Access Compliance Report

Public Rights-of-Way

(Curb Ramps)

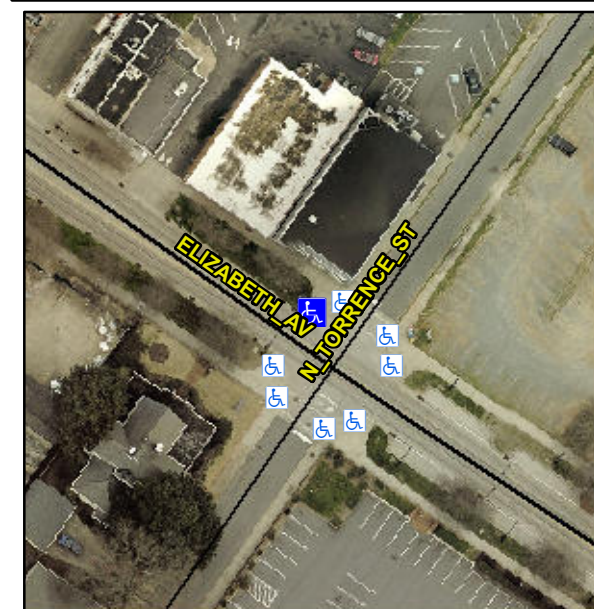
Intersection ID: 13780	Main Street: ELIZABETH_AV	Cross Street: N_TORRENCE_ST	Location: N
ADA ID: 3C7EE7075A95	Ramp Type: Perp	Initial Pass/Fail: Fail	Overall Compliance: No
Severity Score: 12.5			
Codes/Mitigation Info/Possible Solution		Field Measurements/Component Compliance

Not Found, R304.2.2

Remove & Replace Entire Ramp.
